## Explanatory Memorandum

# Sunshine Coast Planning Scheme 2014 (Major Amendment - Palmview Structure Plan and Consequential Amendments)

7 December 2015

**Map1 Palmview Master Planned Area**

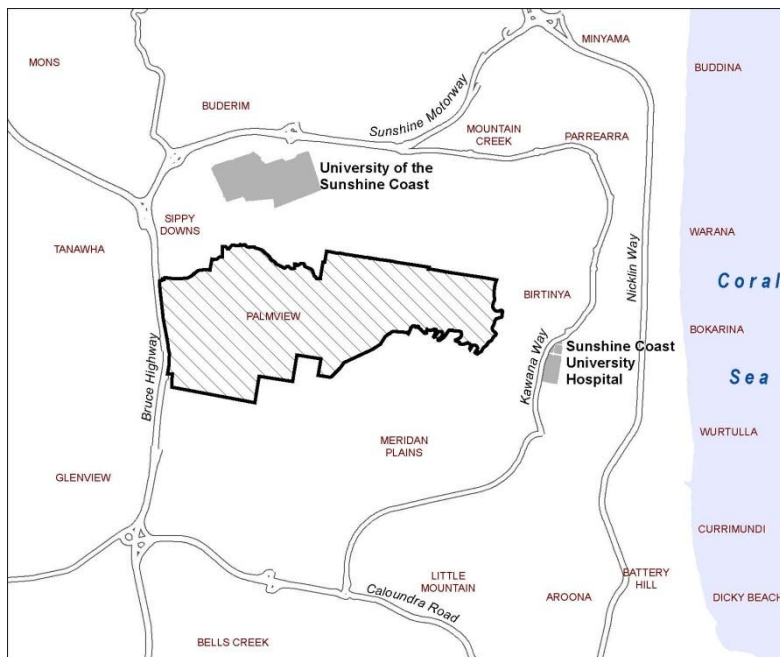
The proposed *Sunshine Coast Planning Scheme 2014* (Major Amendment - Palmview Structure Plan and Consequential Amendments) generally applies to that part of the planning scheme area indicated on Map 1 below and referred to as the Palmview Master Planned Area.
